CITY OF ALBUQUERQUE

Re: Red Robin
2100 Louisianan Blvd
30-Day Temporary Certificate of Occupancy- Transportation Development
Architect's Stamp dated 9-16-16 (J19-D058B)
Certification dated 3-1-17

DRAINAGE AND TRANSPORTATION INFORMATION SHEET (REV 09/2015)

SITE PLAN FOR BUILDING PERMIT

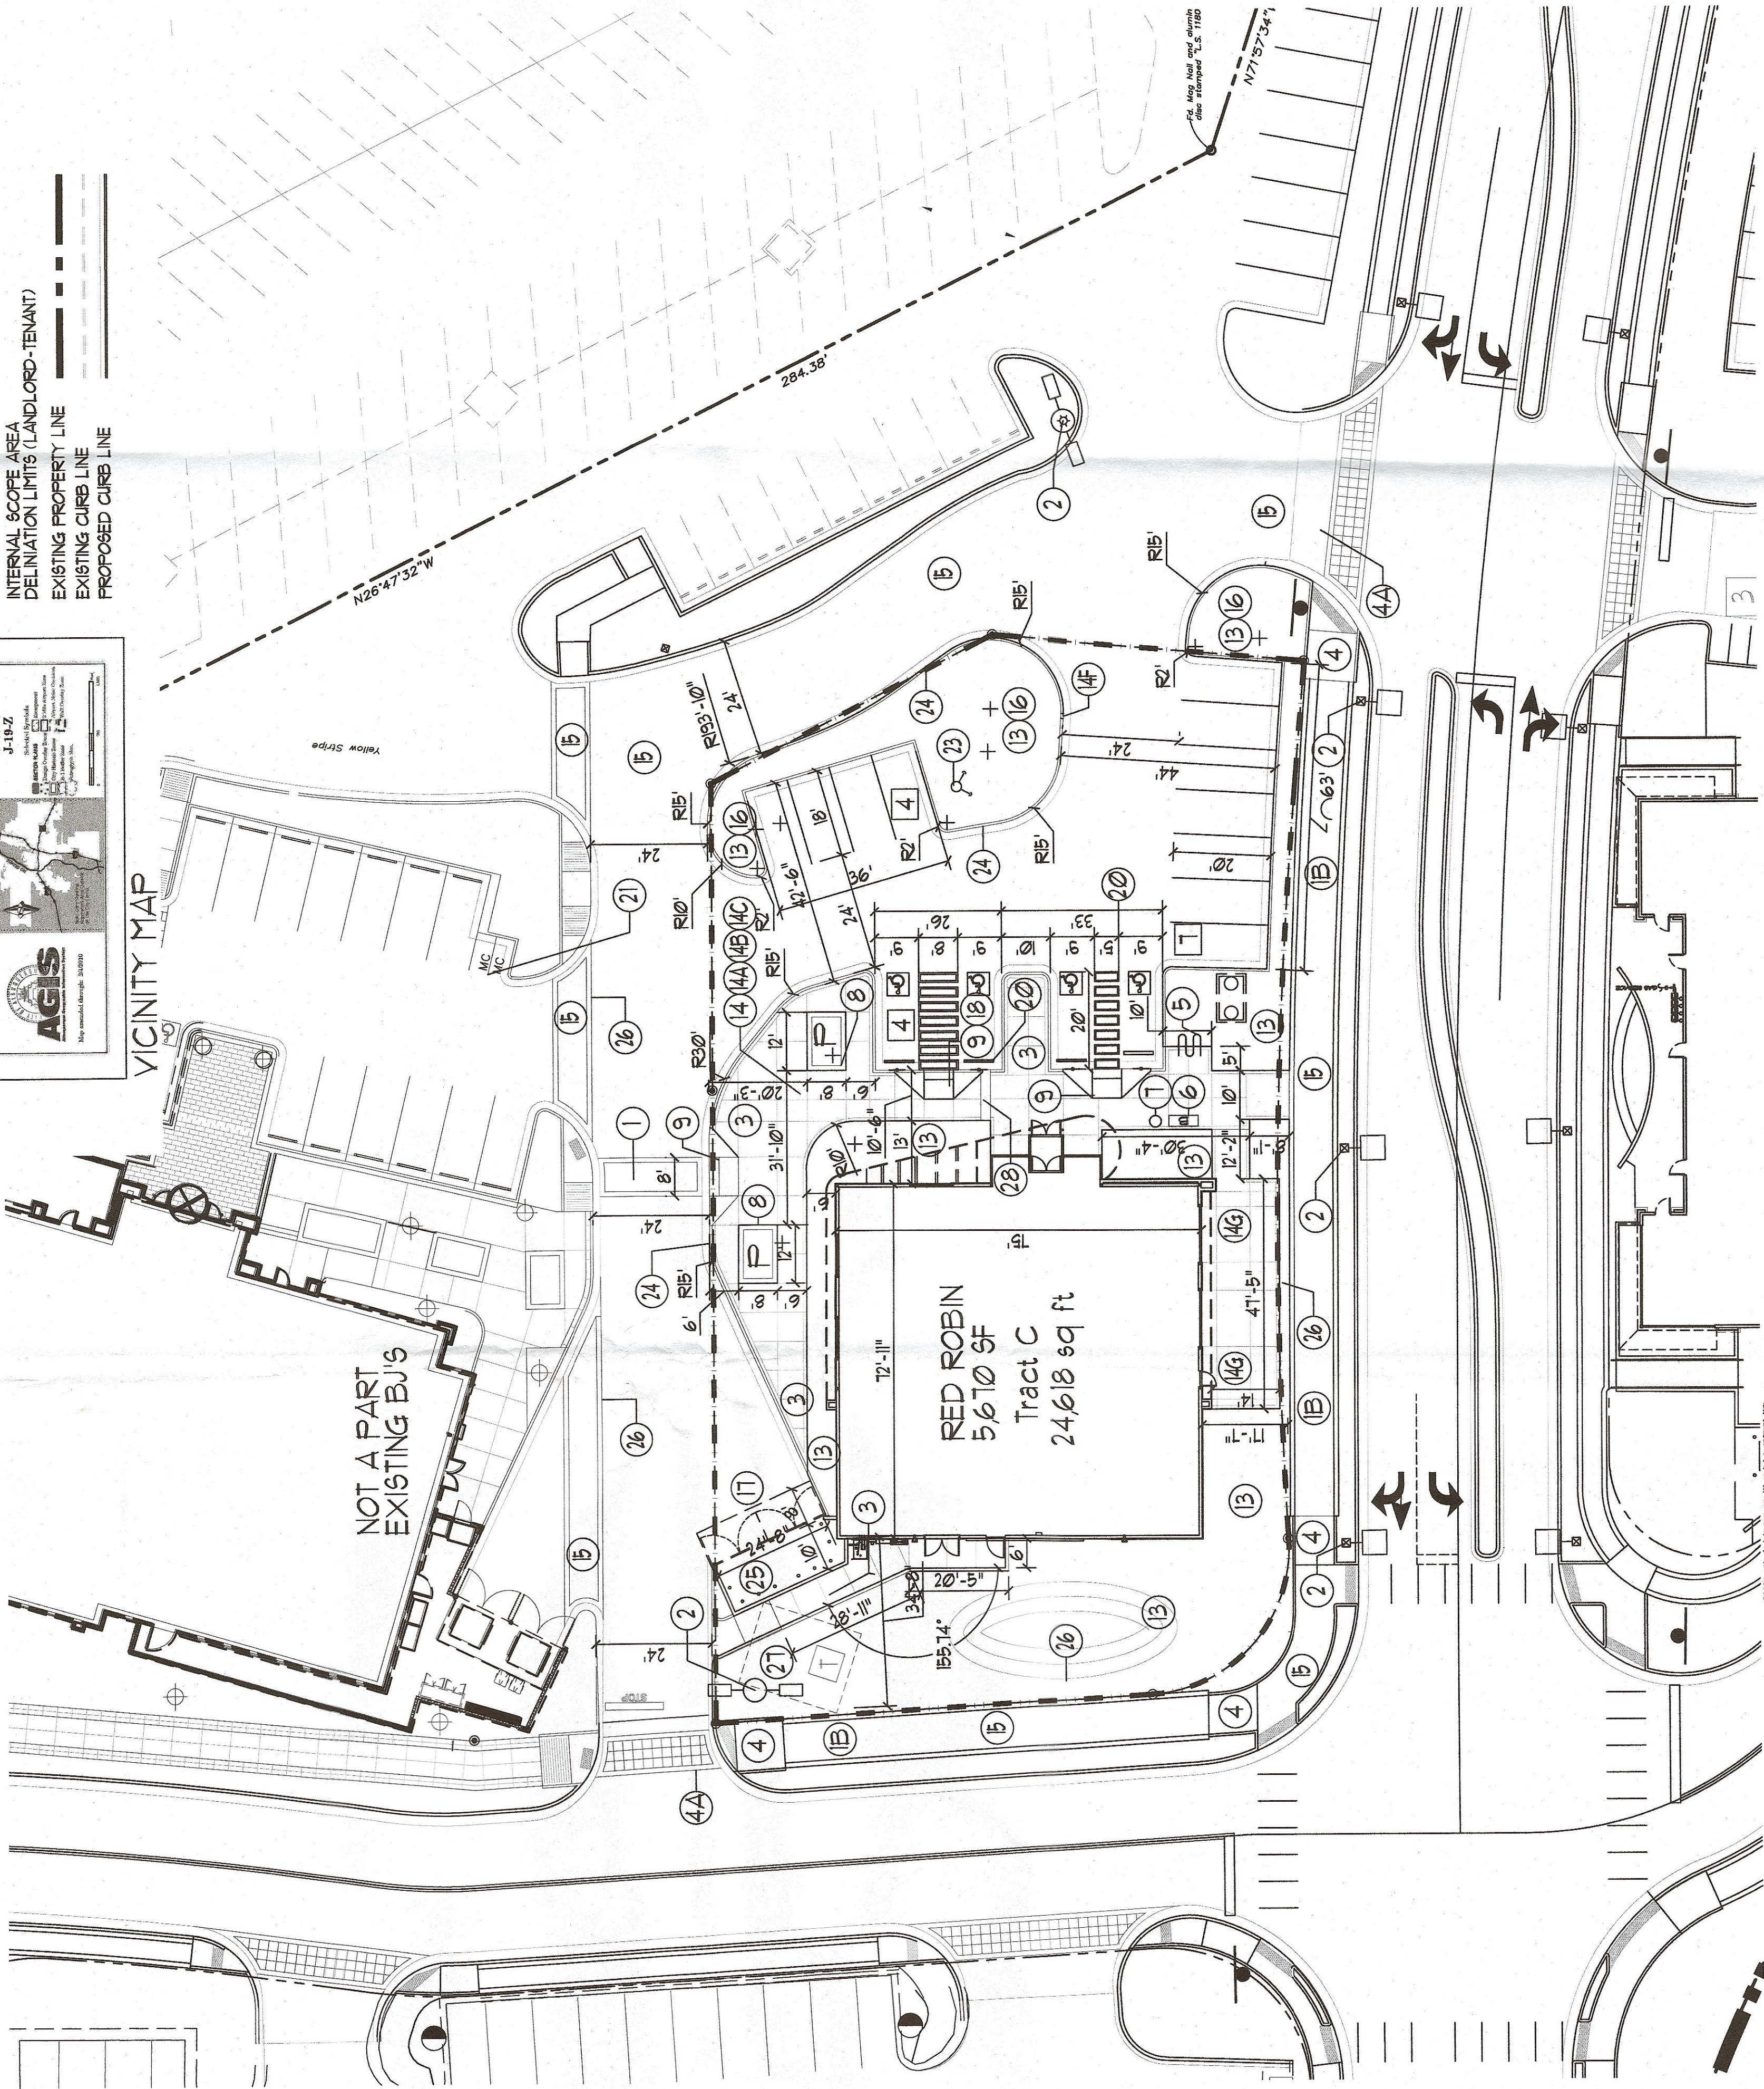
1. The ADA access aisles shall have the words "NO PARKING" in capital letters, each of which shall be at least one foot high and at least two inches wide, placed at the rear of the parking space so as to be close to where an adjacent vehicle's rear tire would be placed. (66-1-4.1.B NMSA 1978)
